**Project:** Stamford Bridge Redevelopment      **Date:** 31 January 2017

**Ref:** APL/00111/HIL4/DGu

**Planning Committee Presentation - 11 January 2017**

### MAP

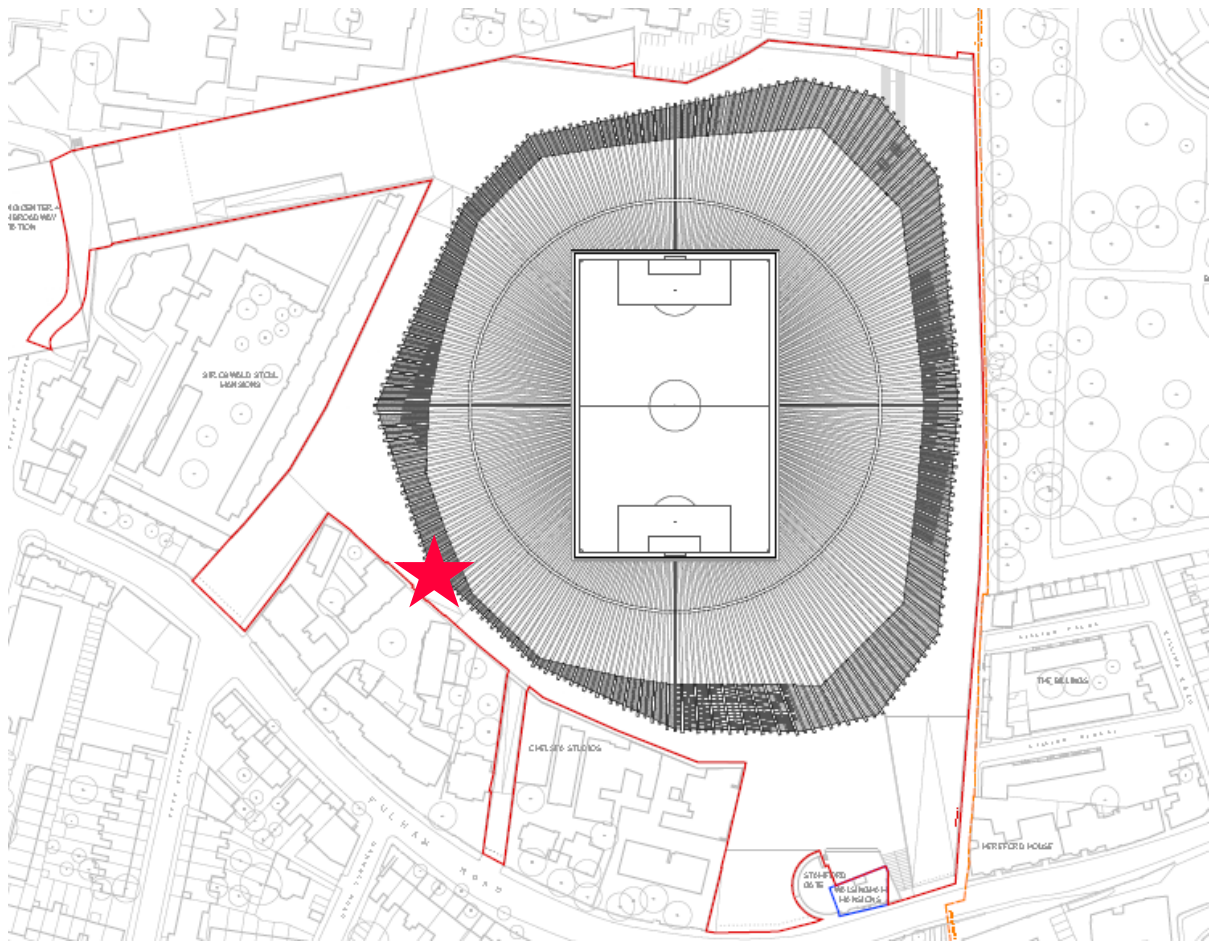
My name is Patric Johnson I live at x Hilary Close with my wife and 2 children, we have an effective party wall with the 'shed' wall as indicated on the map. I have lived there since 2004.

9 See the architects drawing - Section E-E Drawing PN\_ST\_024.

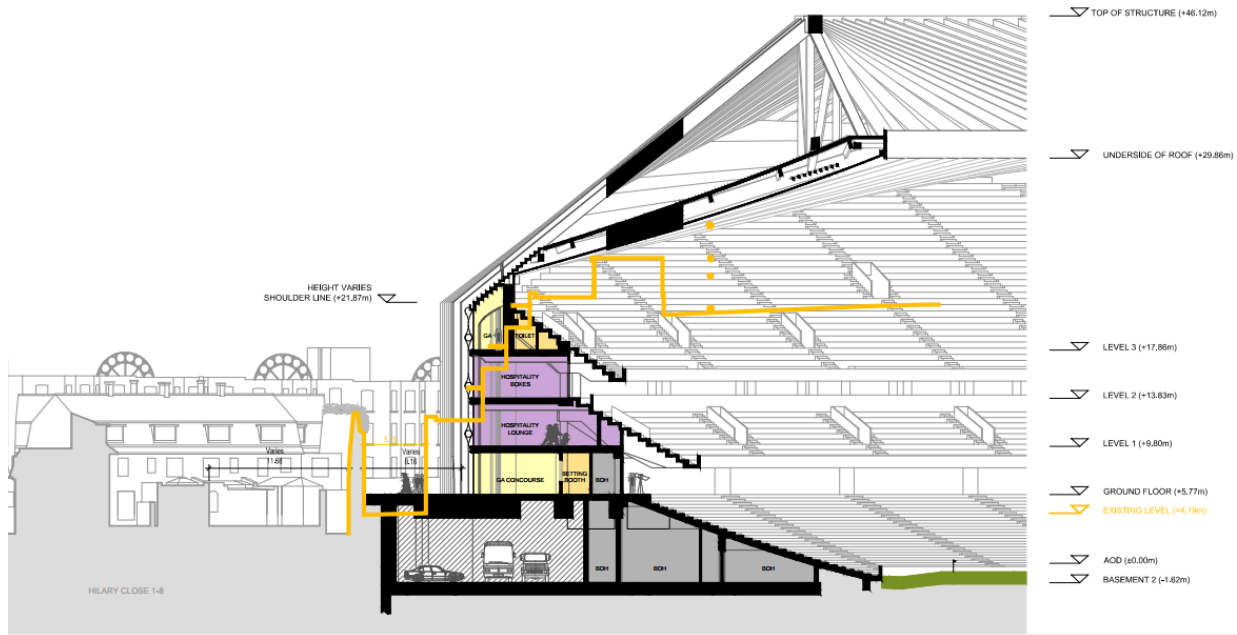
In short we consider that the proposed development by reason of its bulk, mass and scale will result in an over dominant development as it relates to my property and those of our neighbours. The physical mass is overbearing and completely out of scale with the surrounding area. Ignoring the direct loss of light issue, that applicant's consultants have already admitted. I wanted to quote from the within the officer's report (para 4.11.122)in that it says

This statement is simply incorrect. The stadium bears no relationship to its surroundings – it is basically a large gothic **coliseum towering some 32m.....or just over 100ft** above our properties.

(Please see the drawing)
